SUBJECT: Forwards suppl to util 840928 response to NRC 840813 request
 for addl info re proposed amend to spent fuel storage
 facility expansion.Changes involve Item 1.3 on "Region 2
 Racks,Summary of Design Stresses & Min Margins of Safety."

Re: Turkey Points Units 3 & 4
Docket Nos. 50-250 & 50-251
Proposed Amendment to
Spent Fuel Storage Facility Expansion
Additional Information

FLORIDA POWER & LIGHT COMPANY
TURKEY POINT UNITS 3 & 4
PROPOSED AMENDMENT TO SPENT FUEL
STORAGE FACILITY EXPANSION
SUPPLEMENT TO REQUEST FOR ADDITIONAL
INFORMATION - STRUCTURAL BRANCH

FIGURE 3

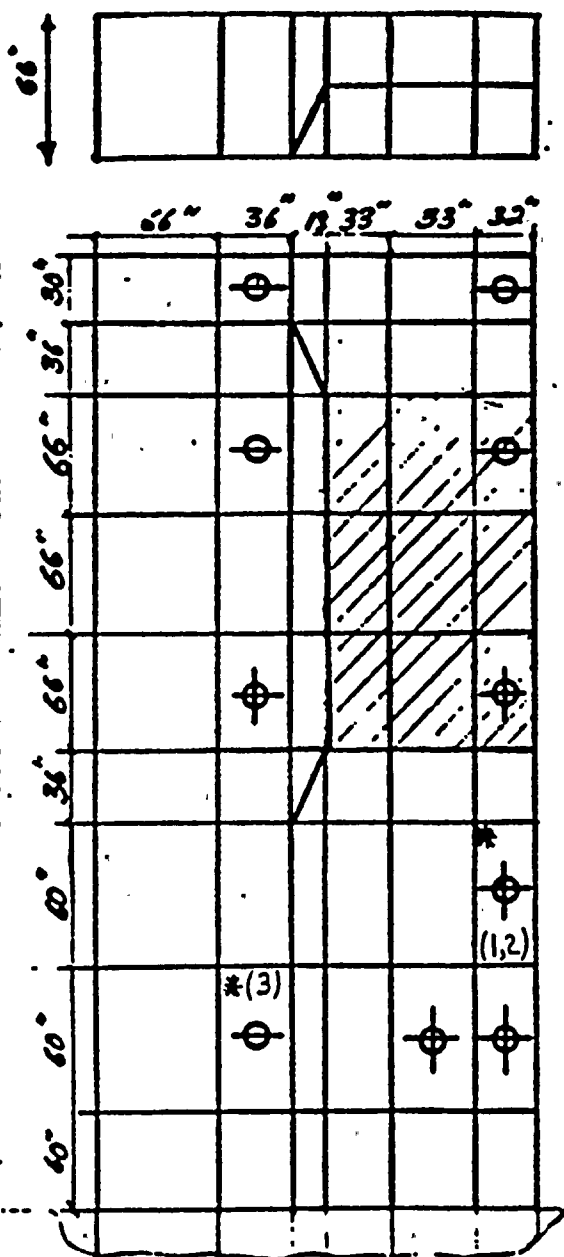
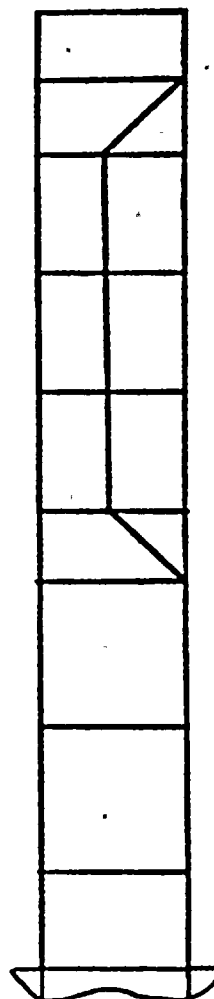
10. Please provide a summary of the stress analysis of the spent fuel pool structure (walls, foundation mat, and liner plates); also the bearing stress of the soil and bed rock supporting the pool.

Representative critical elements of the finite element model in the base mat and all walls were identified based both on high stress results and locations which result in severe loading. These elements are shown in Figures 3 through 7 and were further evaluated in the manner described below:

A summary of the controlling stresses is provided in Table A for the locations identified in Figures 3 through 7. These stresses represent maximum stresses for load transfer. Controlling stresses occur in reinforcing steel, except for one instance where concrete shear governs.
